**Testimony of Manhattan Borough President Gale A. Brewer
19 East Houston Street
ULURP Application Nos. C 140299 PPM, C 140300 ZSM,
C 140301 ZSM, and C 140302 ZSM
September 16, 2014**

**Re: L.U. Nos. 115, 116, 117 & 118
19 East Houston Street
ULURP Applications Nos.**

19 East Houston Street: Images

Presentation for the Council of the City of New York
Subcommittee on Zoning and Franchises

Views of 19 East Houston, looking east from points along West Houston Street

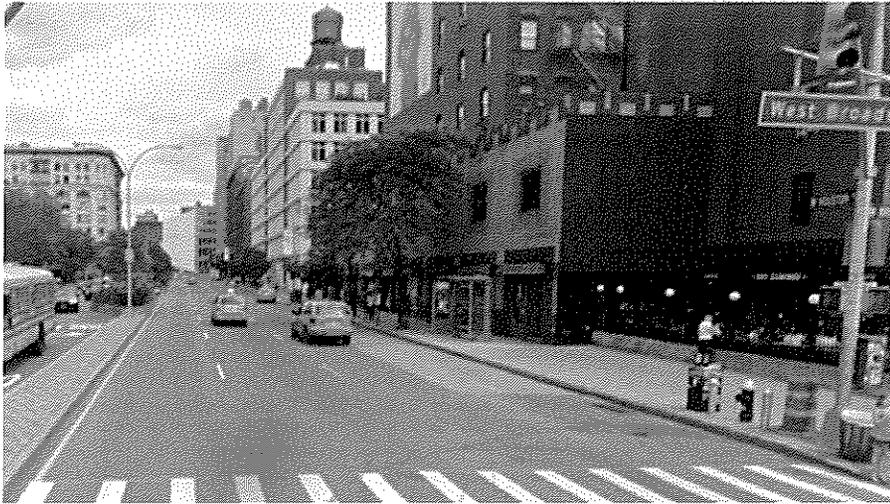
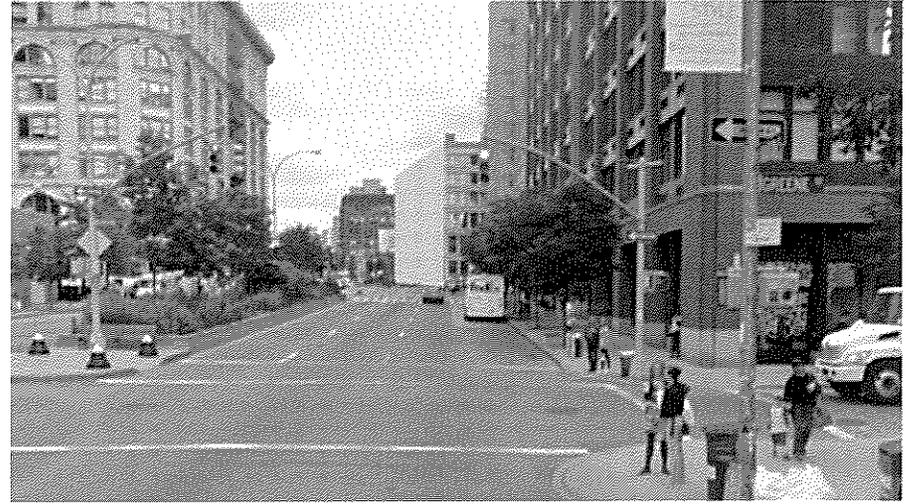
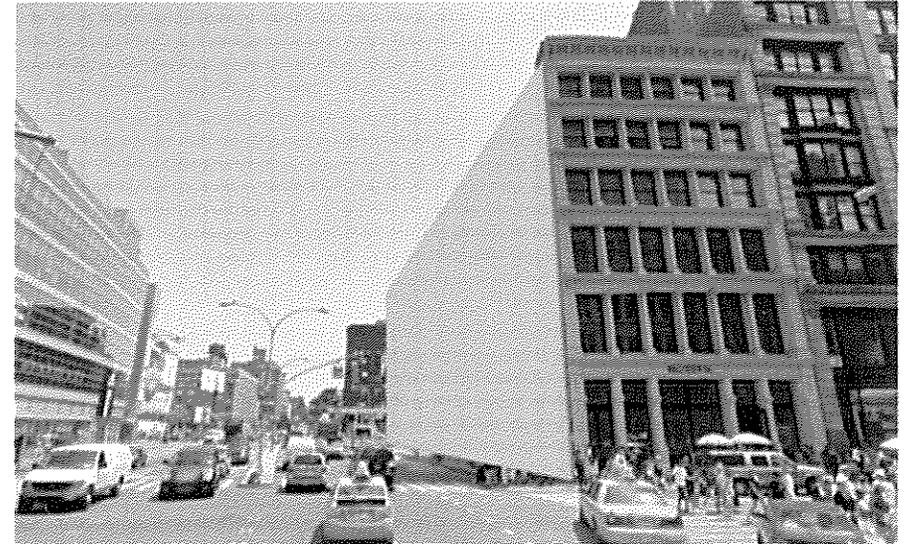
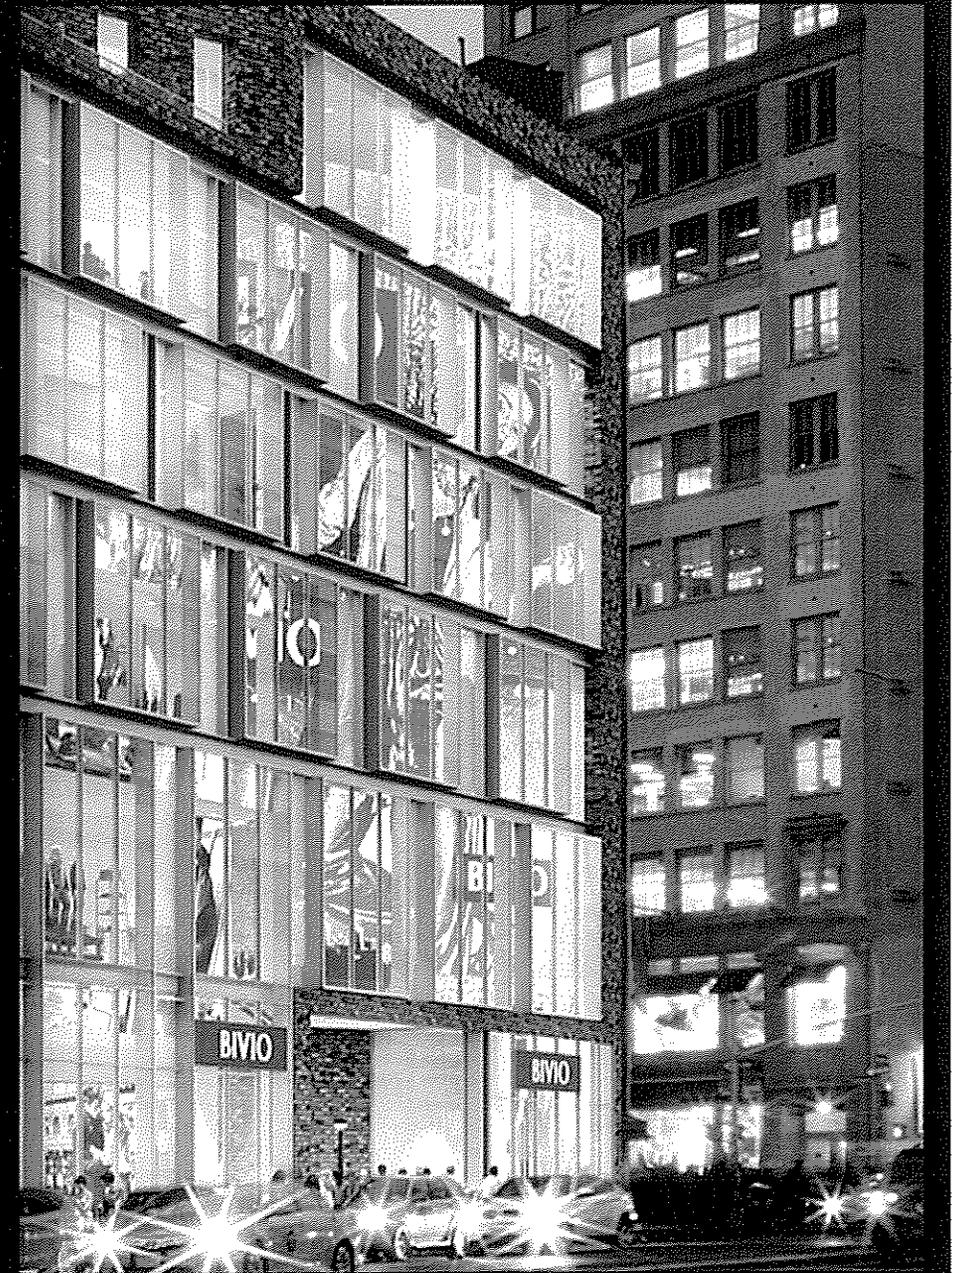
19 East Houston sits at the SE corner intersection of Broadway and Houston Streets (image 1). This is a key northern entry into SoHo, where Houston bends to the NE, creating a prominence that is visible all the way west to Sixth Avenue and beyond, as seen in the attached images (image 2). That high visibility is the real value that this developer wants to cash in on, seeking to maximize return by creating an illuminated branding opportunity (image 3). Any statements from the development team regarding their intention for controls on advertising must be set down in a binding declaration so that those protections against overwhelming lights and displays carry into the future. The developer's July 2014 statement to CPC that "All signage at the development will comply with the applicable Zoning Resolution provisions" fails to address the situation at hand, as the Zoning text is basically silent in regard to interior displays and lighting. Further controls are needed.

19 East Houston Street: Openness Ratio (Comparison of Transparent / Translucent to Solid Facade Materials) *

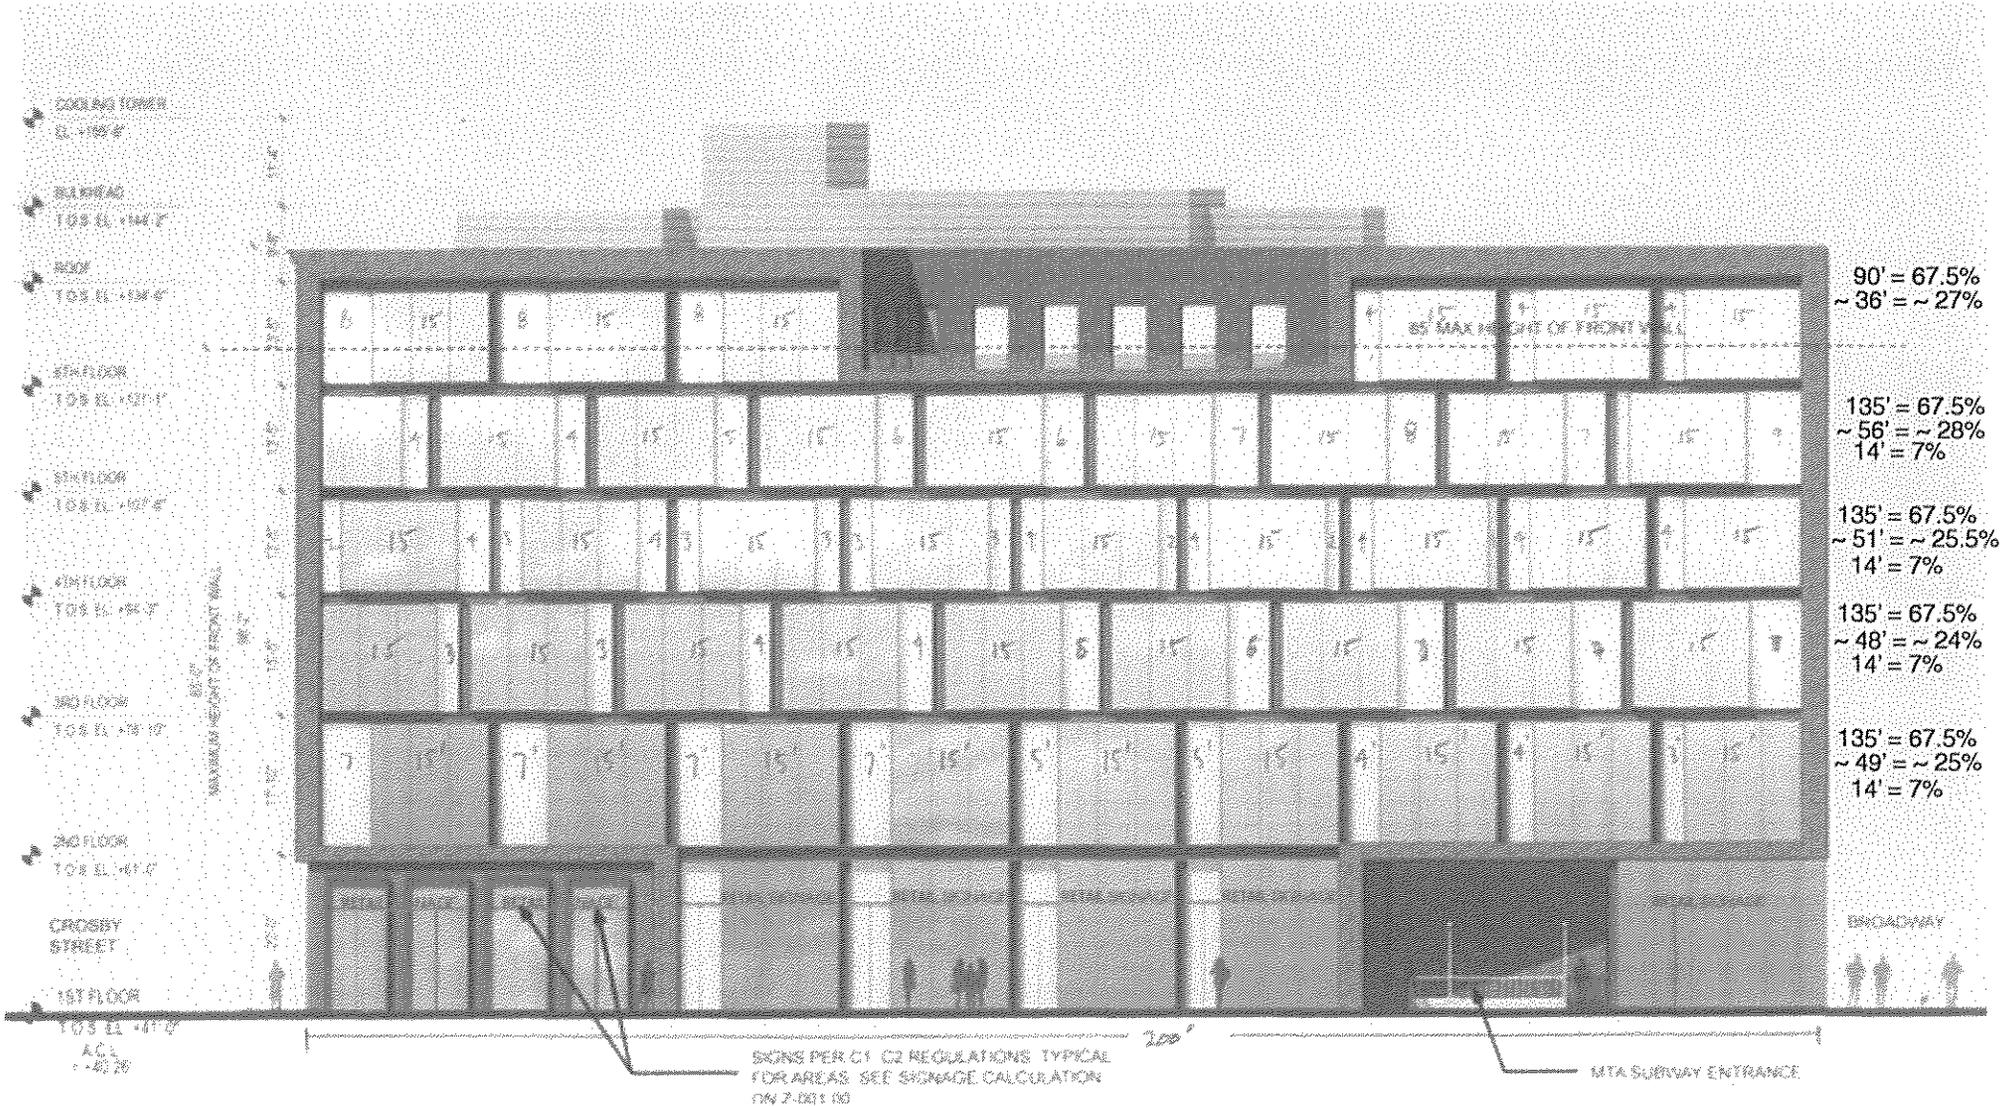
The plan for the north-facing façade of 19 East Houston, rising above the intersection of Broadway and Houston Streets, exhibits a ratio of glass to solid materials that is completely out of character with nearby buildings in the SoHo-Cast Iron Historic District.

In total disregard to the surrounding district, the nearly all-glass façade of 19 East Houston presents a ratio of open glass-to-solid materials of approximately 90% openness (image 5). That high degree of glass far exceeds even the most open of the historic cast iron buildings in SoHo, best evidenced by the Donald Judd Studio at 101 Spring Street. The Judd building exhibits an overall openness ratio of about 65%, with maximum 75% open glass at street level, gradually reducing to 55% open glass at the top 5th Floor (image 6). In contrast, 19 East Houston Street exhibits an openness ratio of approximately 90% overall, with over 65% of fully transparent glass and another 25% of semi-transparent and translucent glass, far in excess of any of the nearby historic buildings. But that openness is in line with the developer's goal to create a building that is essentially, and inappropriately, a glass display case for the planned interior signage. As has been stated, controls must be put in place.

19 East Houston - Issues List and Response

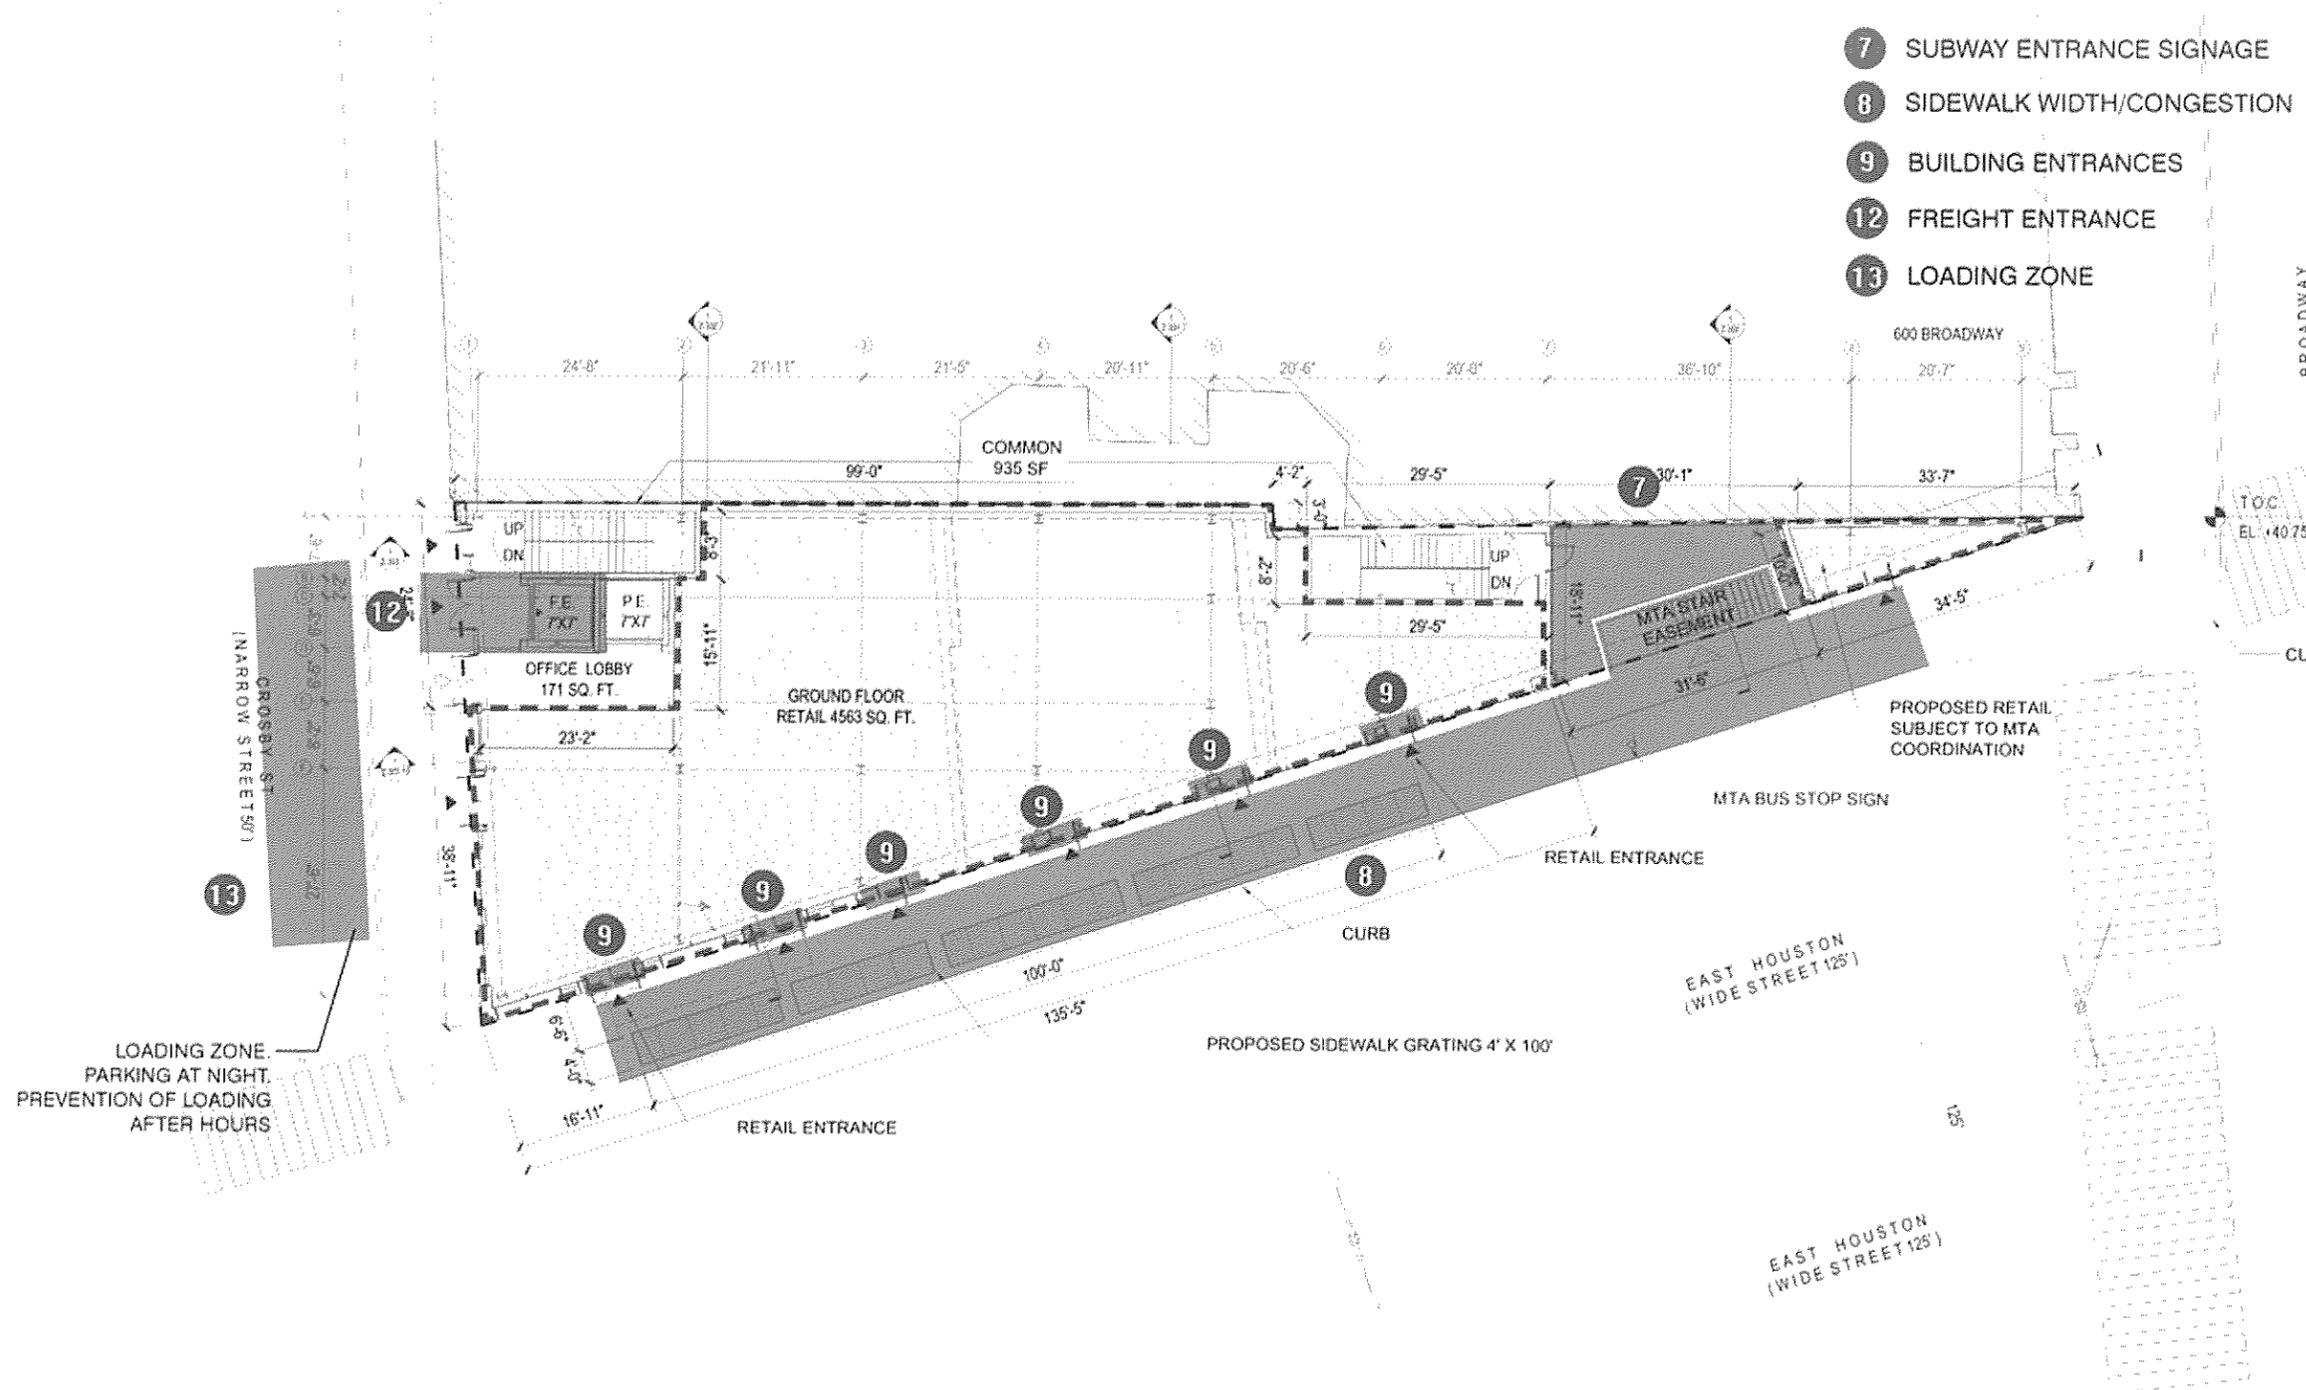
Number	Item	Issue	Developer Response
1	Double Height Retail	Initial design included a double height feature of the retail on Houston St. Parties did not believe this was contextual with the neighborhood;	Removed and replaced with two-floor design.
2	Retail Signage	Initial design allowed for retail signage above first and second floor retail. Parties did not believe this was contextual with the neighborhood;	Second floor signage was removed entirely.
3	Building Height	It was requested that Developer increase the building height to align with adjacent building;	Building height increased to match adjacent building.
4	Alignment of Windows	Initial Crosby St. windows did not align with adjacent building. Community requested that this alignment occur;	Upon increase of height of the building, developer adjusted the window alignment as well.
5	Crosby Façade Material	Initial design of the Crosby St. façade included a glass brick material which concerned the community with respect to it's maintenance and ability to limit interior lighting;	Glass brick feature was replaced with a classic brick appearance to be used on the Crosby St. façade as well as other parts of the exterior.

6	Houston Façade Design	Initial design included glass fin tubes along Houston St. to accentuate the "slicing" story of the building along with levels of opacity to limit the transparency of the glass. Upon further review, general consensus was this was not in keeping with the landmark district aesthetics. Additionally, the community requested that the opacity levels be increased to limit the exposure of the Houston St. interior;	Developer removed glass tubes and increased opacity on the Houston St. glass to further limit transparency.
7	Subway Entrance Signage	Initial design included LED/Interactive signage in area surrounding subway stairs. Parties were concerned how this feature would be built and lit;	Developer removed this feature entirely.
8	Sidewalk Width/Congestion	Community raised concerns regarding the potential for pedestrian congestion on site with the addition of a new building both on the sidewalk and leading into the subway;	Developer obtained DOT approval to widen the sidewalk to a maximum of 3' and is working with MTA on plans to re-develop and widen the stairs currently leading into the subway station. Currently, the subway stairs are 4'11" with the developer preliminarily planning to expand the stairs to a minimum of 6'8". The stairs can potentially be widened even further once excavation work begins and a full survey of existing conditions can be analyzed.

9	Building Entrances	Community voiced concerns over building entrances on Houston St. protruding into the sidewalk and further blocking pedestrian traffic;	Developer re-designed the Houston St. entrances to include doors that will be further inset and only protrude marginally.
11	Building Cornice	Request was made that a building cornice be added to the design to coincide with other landmark district buildings;	Developer added a cornice to both Houston St. and Crosby St..
12	Freight Entrance	Initial design included a dedicated freight entrance along Crosby St. which raised concerns over noise and loading;	Developer removed the freight entrance entirely and the current design only includes one office entrance along Crosby St..
13	Loading Zone	Community raised concerns over the potential loading areas for the retail. Initially, the community requested that no loading occur on Crosby St. However, placing loading on Houston St. would limit the sidewalk widening previously mentioned to only 2'. As a result, loading zone has been placed on Crosby St. to fulfill the request to widen the sidewalk by maximum allowability;	Developer re-worked the sidewalk/loading designs multiple times at the request of the community. The current design allows for loading on Crosby St. to coincide with CB2's request.

14	Advertising Signage	Concerns were raised regarding advertising signage in the atrium area	To allay such concerns, Developer committed to not include any advertising signage in the atrium area.
15	MTA Fan Plant	Parties requested if the MTA had completed a review of the existing fan plant underneath the site and if adequate planning had been done to allow for the vent relocation;	Developer has worked with MTA extensively since being selected for this project and the MTA has confirmed that the relocation of the vents will have no effect on the operation of the fan plant and that the planned building does not prevent MTA from expanding the fan plant in the future.
